Access Compliance Report Public Rights-of-Way (Curb Ramps)

Intersection ID: 43922 Main Street: NORTH_COMMUNITY_HOUSE_& Street: JOHNSTON_RD Location: SE

ADA ID: AC4AC70AE59D Ramp Type: Perp Initial Pass/Fail: Fail **Overall Compliance: No** Severity Score: 18.75

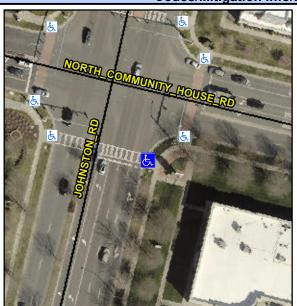
Field Measurements/Component Compliance						
Compl	iance Description	Data	Comp	liance	Description	Data
N/A	Ramp Length (in)	118.0	Yes	Ramp	Slope (%)	7.8
No	Ramp Width (in)	35.0	No	Ramp	XSlope (%)	3.6
N/A	Flare Type LT	N/A	N/A	Flare Type RT		N/A
N/A	Flare Slope LT (%)	N/A	N/A	Flare Slope RT (%)		N/A
N/A	Flare Traversable LT?	N/A	N/A	Flare	Traversable RT?	N/A
N/A	Landing Length (in)	N/A	N/A	DWS	Provided?	N/A
N/A	Landing Width (in)	N/A	N/A	DWS	Contrast?	N/A
N/A	Landing Slope (%)	N/A	N/A	DWS	Length (in)	N/A
N/A	Landing X Slope (%)	N/A	N/A	DWS	Full Width?	N/A
N/A	Landing Curb? (Y/N)	N/A	N/A	DWS	Offset (in)	N/A
N/A	Shared Landing?	N/A				
N/A	Gutter Ponding?	N/A	N/A	Gutte	r Slope (%)	N/A
N/A	Gutter Lip Ht (in)	N/A	N/A	Gutte	r X Slope (%)	N/A
N/A	Painted X Walk1?	Yes	N/A	Paint	ed X Walk2?	N/A
	X Walk 1 Direction	To NW		X Wa	lk 2 Direction	N/A
N/A	X Walk 1 Width (in)	118.0	N/A	X Wa	lk 2 Width (in)	N/A
	X Walk 1 Slope (%)	1.8		X Wa	lk 2 Slope (%)	N/A

JOHNSTON RD Street 1 Name Stop Condition-Street 2 Signal Street 2 Name N/A Stop Condition-Street 1 N/A Possible Solutions: Remove & Replace Entire Ramp. Surveyor Notes: N/A PROW/ADA: R304.5.1, R304.5.3
